**PCI RESPONSES TO CITY 4/19/24 3RD SUFFICIENCY REVIEW LETTER,
DATED 6/14/24**

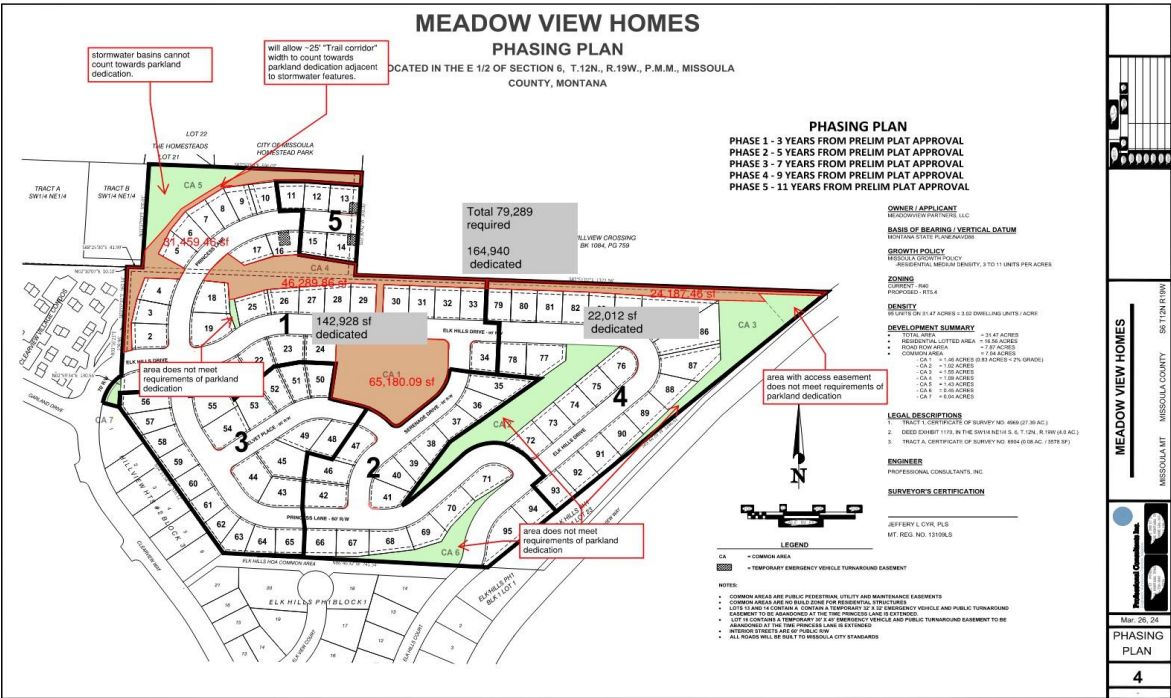
1. Parkland Dedication: The parkland dedication calculations do not appear to be correct. Certain areas are counted that do not qualify - see the image below of highlighted areas that appear to meet the requirements for parkland dedication (note: the numbers are not necessarily accurate). There appears to be more than enough common area (parkland) dedicated to meet the requirements overall, however, but a breakdown per phase is needed. Note: Areas including stormwater facilities cannot count towards parkland dedication. **See Revised map titled, "Parkland/ Common Area Requirements and Dedications Per Phase", which is based on the calculations and areas presented to us from Parks. We are using their same calculation for the area west of Princess, or 31,459 square feet, and CA 4 in Phase 1 to include the 20-foot PAE, or 46,298 square feet. In the area along the Tonkin Tail, because we are required to show two walkways through 20-foot Public Pedestrian Easements (PPE's) between Lots 37 & 38 and between Lots 44 & 45, we are adding those two areas plus a 20-foot wide area extending from the back of Lots 44 & 45 to the northeast corner to contain a trail as also required. These additional areas come to 6960 square feet, so when added to Parks' number of 22,012 square feet of dedicated area we are showing 29,872 square feet. CA1 was reduced from 64,469 square feet to 35,719 square feet. There have been a recent requests for the applicant to build a public pedestrian trail from the northeast corner of CA5 down to the bottom of the hill at Wapikiya Park and a 400-foot long paved surface for a trail and maintenance track beyond the bottom of the hill. With all these increases in trails and hiking opportunities, the applicant is attempting to balance public benefit with the cost of**

such recreational amenities by agreeing to these requirements while lessening the area of CA1. CA1 will be 0.82 acres, or 35,719 square feet, with just over half that in land area that is less than 2 per cent slope. It will be a gathering and recreation area that may later contain items such as play equipment, picnic table, perhaps a gazebo or bandshell, etc. We have so much on our plate right now to discuss and figure out, that any planning for CA1 recreational improvements will be accomplished later.

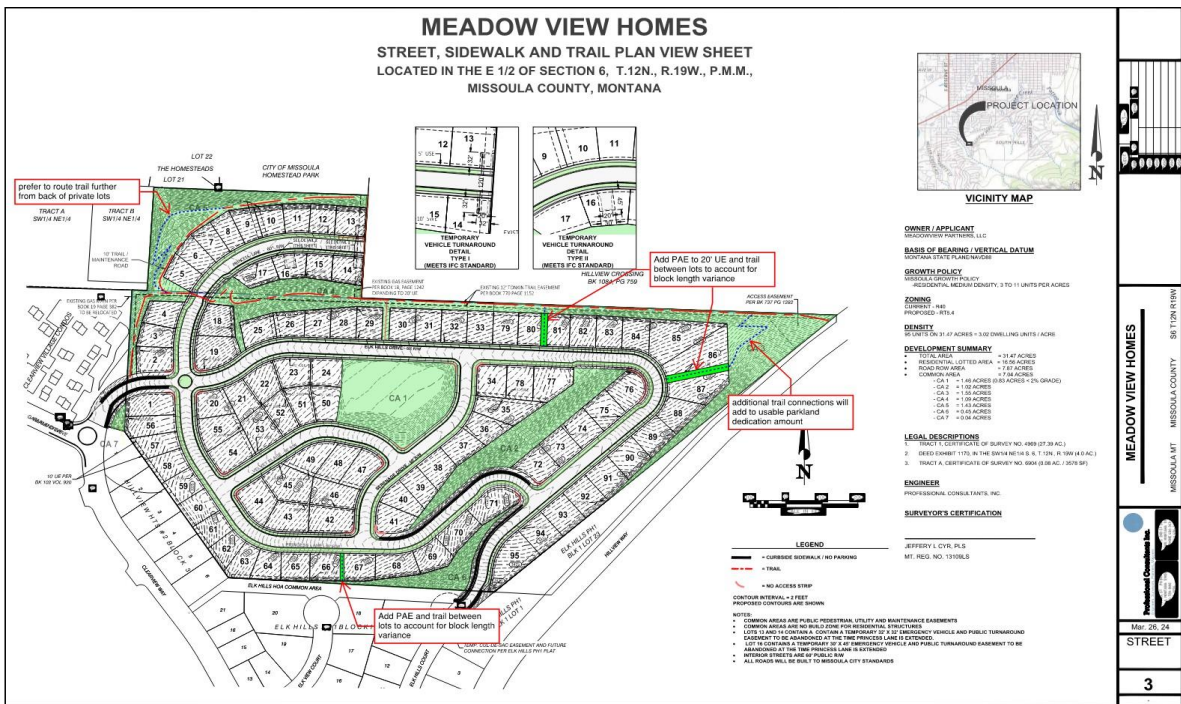
2. Block Length Variance: In order to support the block length variance several public access easements with trails should be added as shown in the below preliminary plat markup. We have added three new 20-foot Public Pedestrian Easements (PPE's) as shown on Park's diagram- between 1) Lots 37 & 38, 2) Lots 44 & 45, and 3) Lots 73 & 74. It would not be a good idea to build a trail between Lots 73 and 74 because of steep grade there. It would only connect to CA 6, which is also steep and does not count toward parkland dedication. CA 6 does abut to the Elk Hills HOA Common Area which is private property. There could possibly later be an inter-access agreement with the Elk Hills HOA whereby the MVH HOA could build stairs to connect.
